## **Proposal for the 04 series of amendments to UN Regulation No. 80 (Strength of seats and their anchorages (buses))**

### **Submitted by the expert from Germany\***

**"Annex 3**

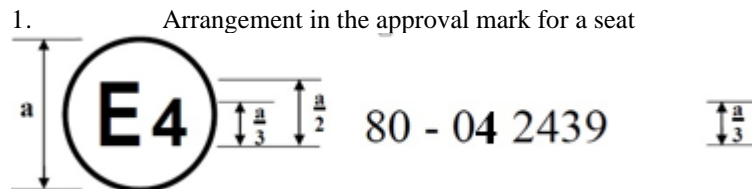
The above approval mark affixed to a seat shows that the seat type concerned has, with regard to the strength of the seats, the test being carried out in accordance with paragraph 2 of Annex 4, been approved in the Netherlands (E4) under number 0342439. The approval number indicates that the approval was granted in accordance with the requirements of Regulation No. 80 as amended by the 034 series of amendments.

2. Arrangement in the approval mark for a vehicle type

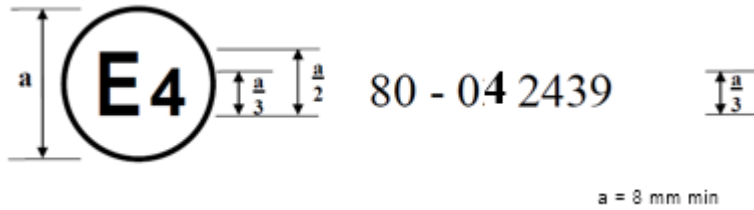
The above approval mark, affixed to a vehicle, shows that this type of vehicle has been approved in the Netherlands (E4) under number 0342439 with regard to the strength of the anchorages on the vehicle. The approval number indicates that the approval was granted in accordance with the requirements of Regulation No. 80 as amended by the 034 series of amendments."
